### INSTRUMENTATION AND MONITORING OF TIEBACK WALL ON SUM82 AT BTECKSVILLE

CP-07 – Revised Wali Procedure – Resolution Proposal

> RE: Review and Response to Various Questions Two-Tier Tieback Wall System Vallay Raliway Slope Stabilization Project Cuyahoga Valley National Recreation Area AWK Project No. 99018

SUBJECT: Slope Stabilization Under SR 82 Bridge (SUM-82-0.00) Response to contractor's review of Wall Design

> TYPICAL PLAN VINW FOR WALL IN EXCAVATED COMBINON

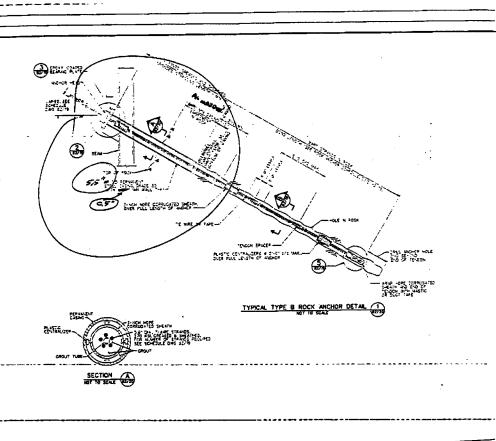
IP ADD'L CLEARANCE IS REQUIRED FOR THE PLACEMENT OF BACKFILL BETWEEN THE TEMPORERY LAGGING + THE PERMANENT BOTHERS THE TEMP. LAGGING . THE H. PILING,

FIGURE 5.7.1A Guidelians for Emissering Farth Pressure on White with Two or More Levels of Anchors
Countracted from the Top Down
Maddined after Toronghi and Peck (1967)

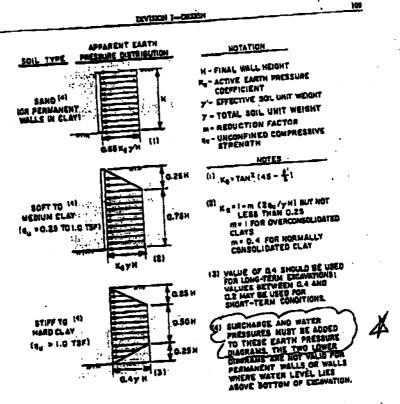
- Temporary Loads Due to Staged Construction: The design calculations do not include stability analyses for intermediate stages of construction as specified by AASHTO on Sheet AP. Thus, additional calculations are required to evaluate the inspect of temporary loads during journmediate stages of construction.

- 1) Design Pressure: The walls as designed are adequate. The walls were designed as two separate systems. The design pressure for the pre-cast lagging is correct as shown on the plans for the final service pressure. The contractor is responsible for any sheeting and shoring to prevent over stressing of the lagging during the construction (i.e. temporary lagging for the full height of the wall).

- 2) Temporary Loads Due to Staged Construction: ODOT feels that these loads were incorporated into the original design based on specified construction sequence (top down construction). The contractor is to provide calculations for the revised sequence of construction showing that the wall components are adequate. These calculations should also include the temporary lagging, including size and grade of hardwood planking or plates. In the contractor's revised procedure dated January 25, 1999, please clarify if the temporary lagging is to be left in place or to be removed.

Fig.3 Plan view

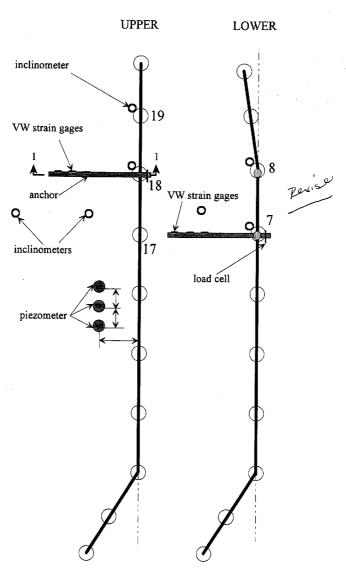
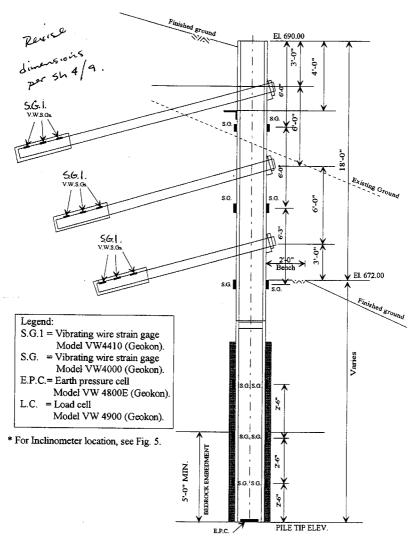
5. Project Manual, Pages 11600-3 and 11600-4: Figures 3 and 4 detailing the Sociations of the instrumentation need to be revised to reflect the re-design.

Fig. 7 Details of the design of the concrete box for the data collection system

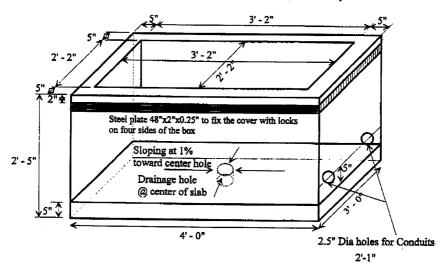
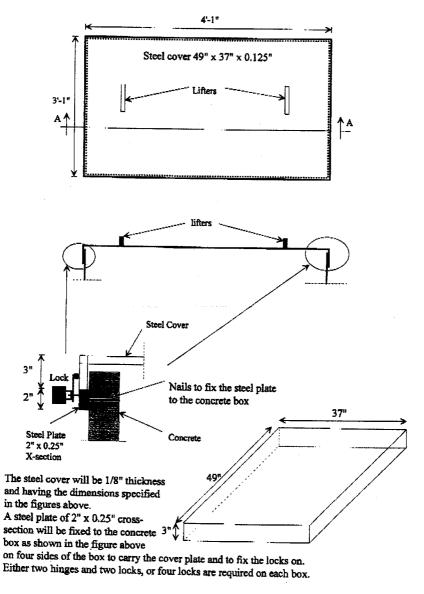
The specifications regarding the instrumentation appear to be satisfactory, although the lump sum item for Research Assistance raises some concern if something unforeseen should occur. I noticed that the steel plate cover for the instrumentation box was quite heavy. After discussing this with Dr. Liang, he will be sending you a revision of Figure 7 in the specifications.
